Modification of application MP 05_0199 MOD 2 - Rosedale residential subdivision

Thank you for the opportunity to review the proposed modification of application MP 05_0199 MOD 2 - Rosedale residential subdivision.

Attachment 1

Figure 1: Showing Watercourse 2D encroachment area which is planned to be replaced by a detention basin instead of retaining a vegetated buffer around this watercourse

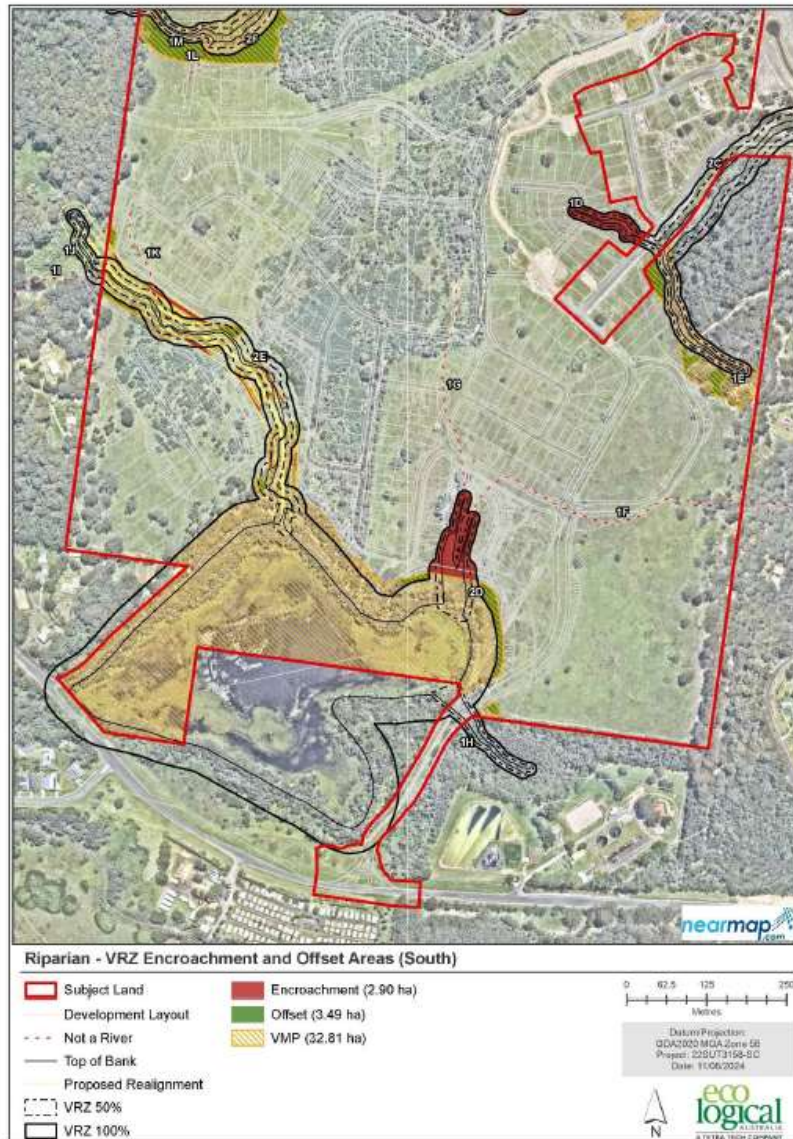
The second order stream identified as 2D, which drains directly into Bevan wetland is planned to be replaced by an online stormwater detention basin. This encroachment into the required riparian area is intended to be offset elsewhere (Figure 1). Natural Resources Access Regulator (NRAR) and DPI-Fisheries should be consulted to ensure that all of the planned stream modifications, riparian corridor widths and offsets, including for watercourse 2D meet with their requirements. The restoration of riparian corridors, in addition to their protection throughout the development will help to improve waterway health and biodiversity outcomes.

Figure 2: Bore holes from the Acid Sulfate Report Civile June 2024.

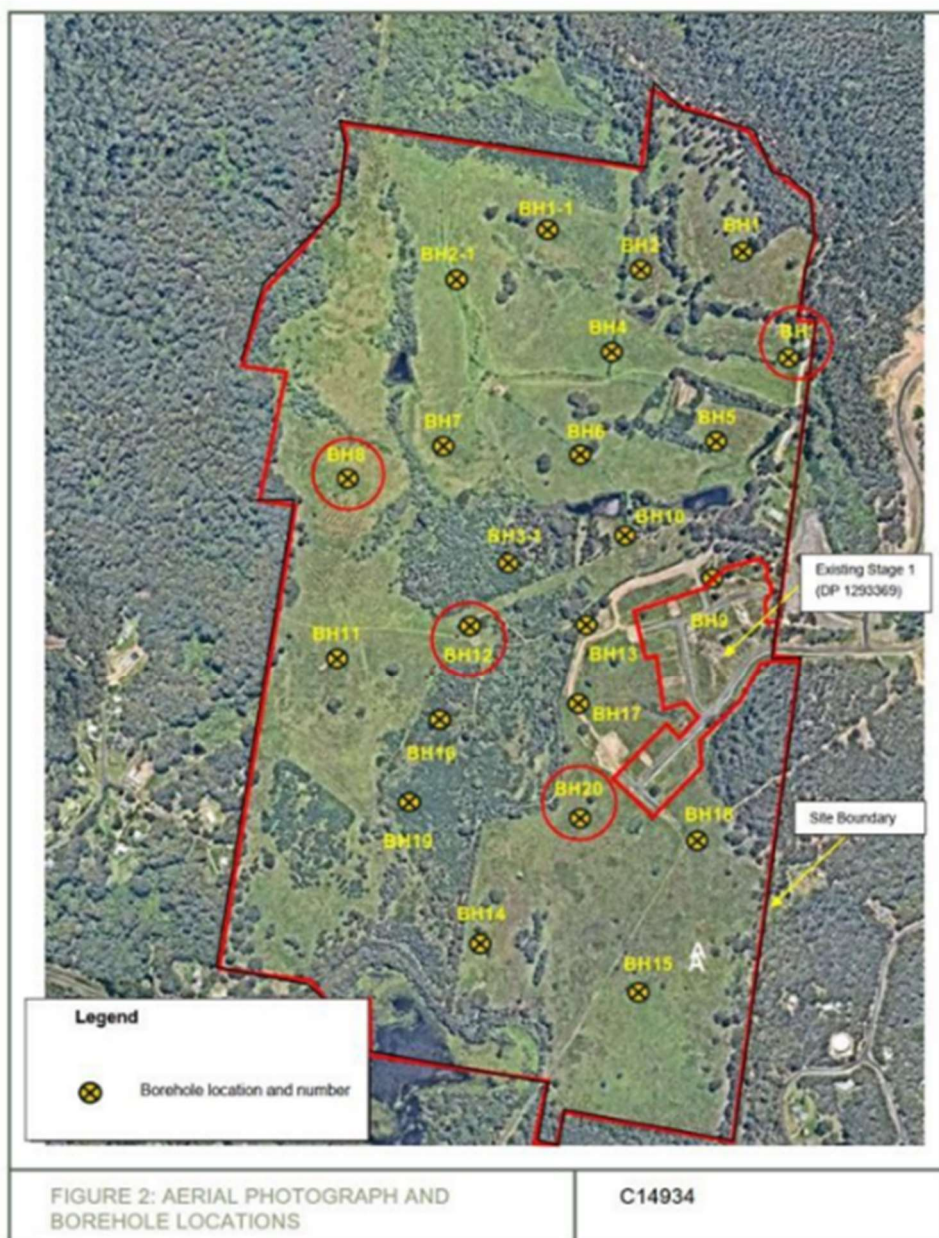
The development of low-lying areas (Figure 6), filling of land and treatment of acid sulfate soils recorded on the site (Figure 2) has significant potential to alter the current hydrological regimes, increase sedimentation to the Bevan wetland and negatively impact *Persicaria elatior*. The current development does not demonstrate avoidance or minimisation of impacts to these values. The exact dimensions of the buffer to the wetland and *Persicaria* from the development are not detailed in the BDAR or site plans nor are there sufficient measures to ensure that surface water flows into the wetland will be maintained. The proposed flood mitigation measures (sediment basins) as shown on the site plans (Figure 7) will be impacted by increased 1-2m flood depths in a PMF and 1% flood event and are in close proximity to the wetland and *Persicaria* locations. Given the scale of the development, flooding potential under a 1% flood event has potential to increase impacts to these values if sediment basins are not appropriately sized (Figure 9)

Figure 3: TEC extent on site observed by BCS

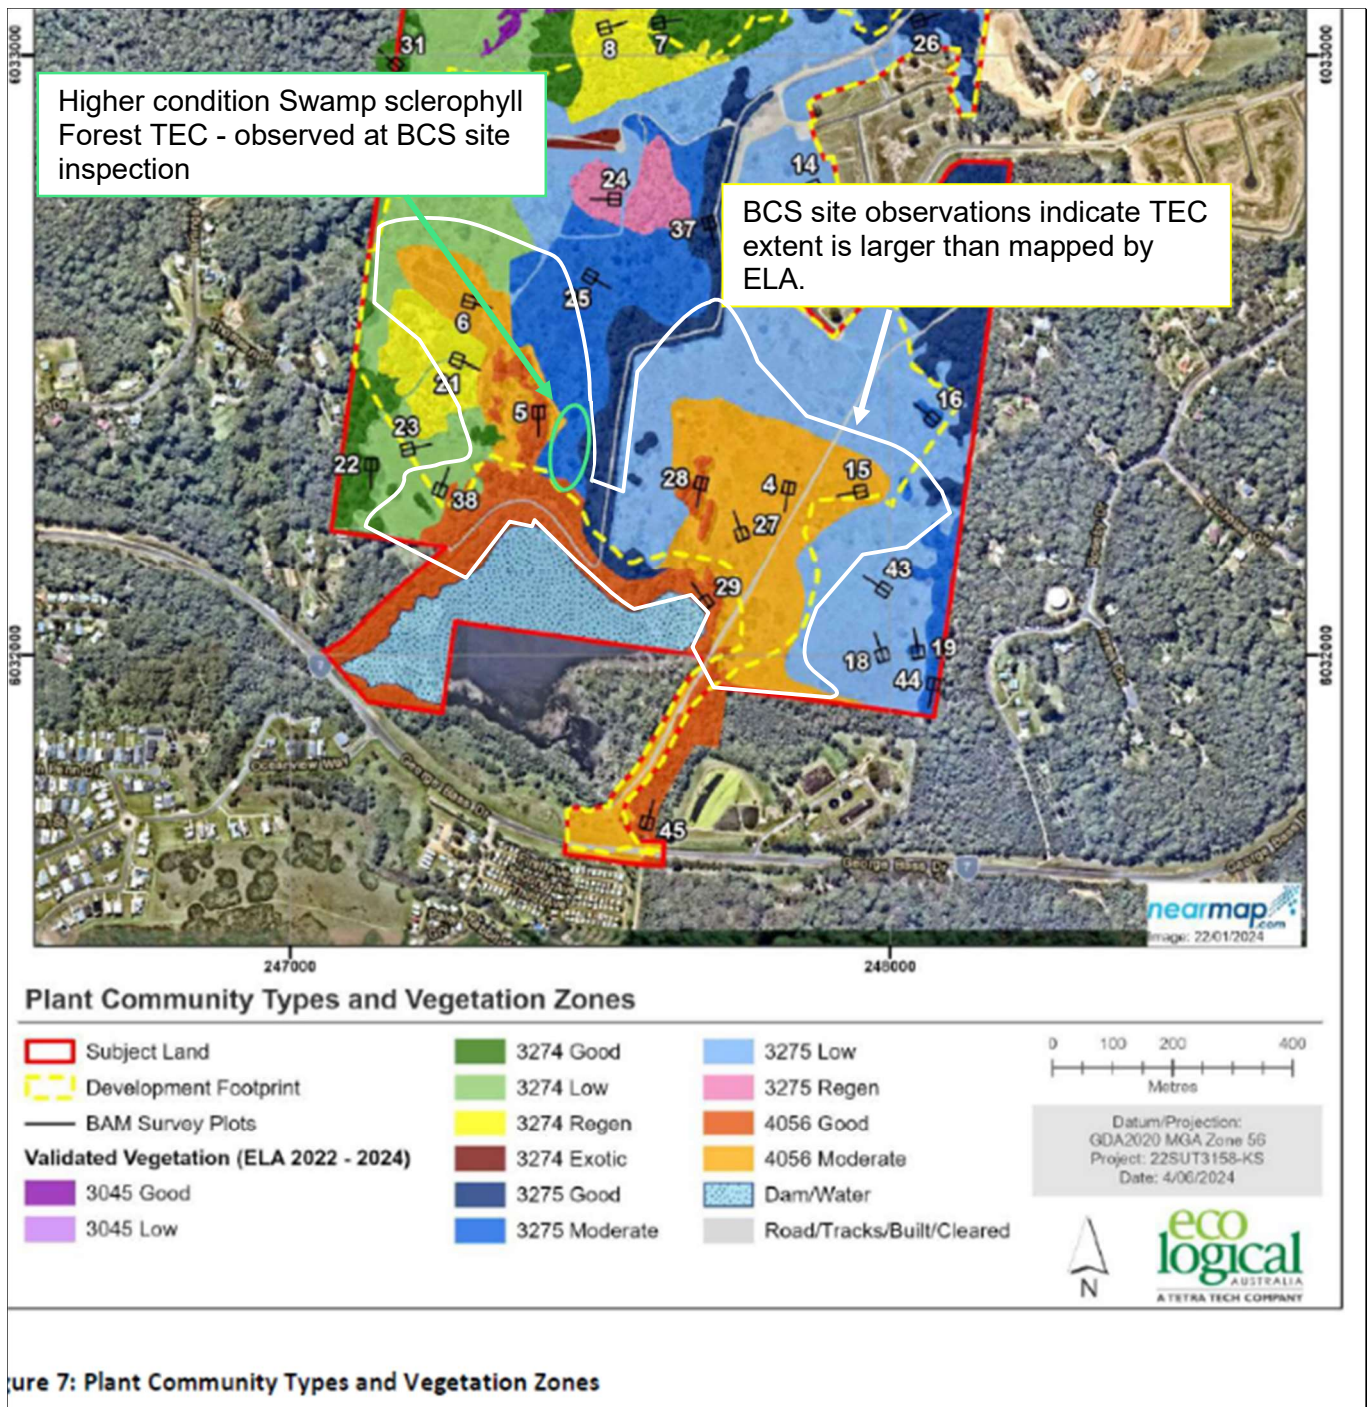
Although the site has been historically cleared and regularly slashed, it was observed that there remains good diversity and recovery potential for a larger extent of Swamp Sclerophyll Forest TEC and Swamp oak Floodplain Forest TEC than is acknowledged in the BDAR (Figure 3 – Figure 4 & 5). These areas are generally low lying, correspond with predicted acid sulfate soils (Civille 2024) (<10mAHD) and drain directly into the Bevan Wetland. The acid sulfate soil report (Civille 2024) indicates that ASS occur on the site at BH 20 (Figure 2) and are likely to occur under 10m elevations where there is a sizeable proportion of the proposed development footprint.

Figure 9: Predicted flooding of 1-2m and limited buffer between sediment basin and wetland

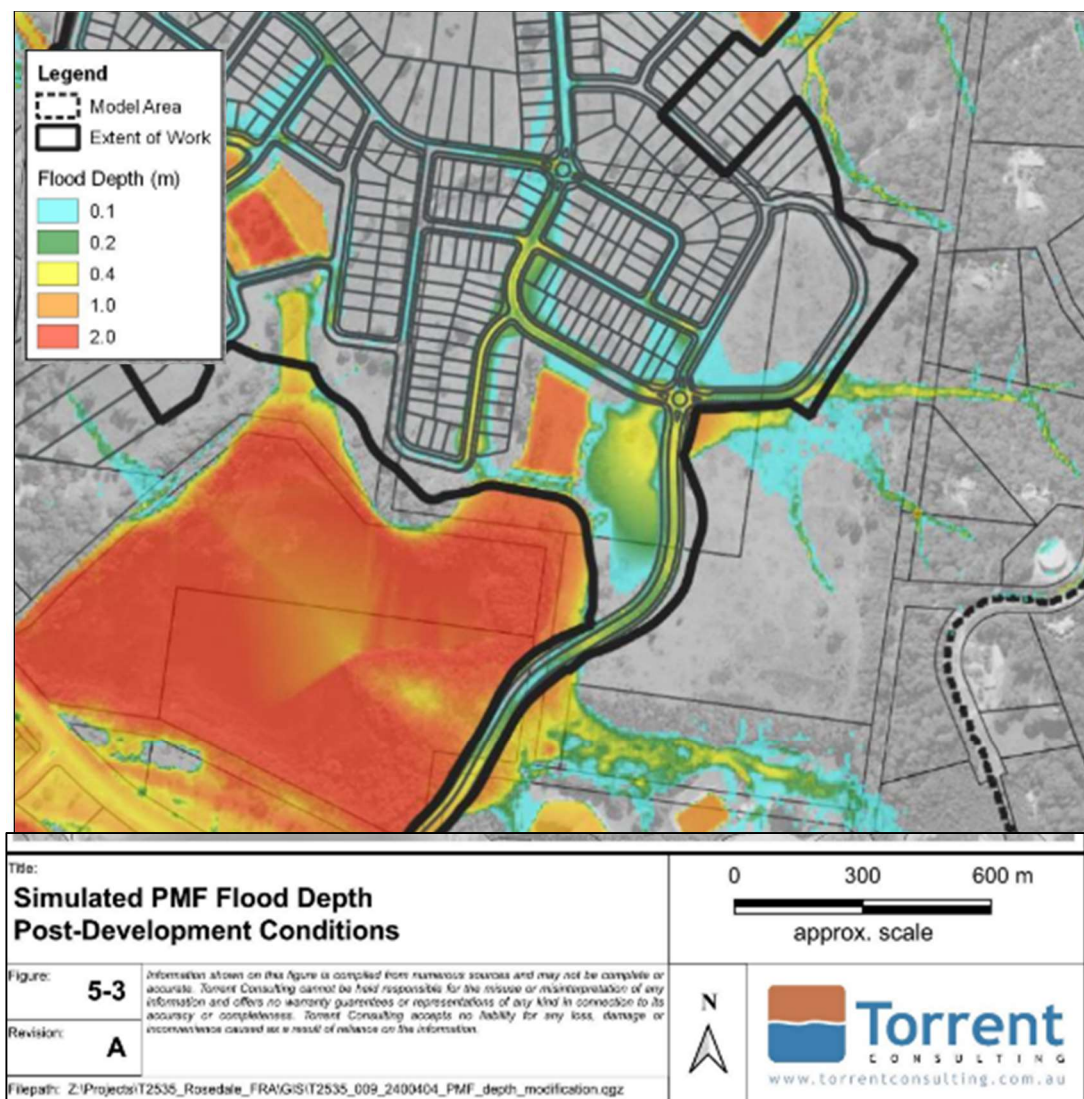
The proposed flood mitigation measures, particularly the sediment basins, will need to be sufficiently sized to prevent overtopping in a PMF and 1% flood event given the scale of development and proximity to the wetland.
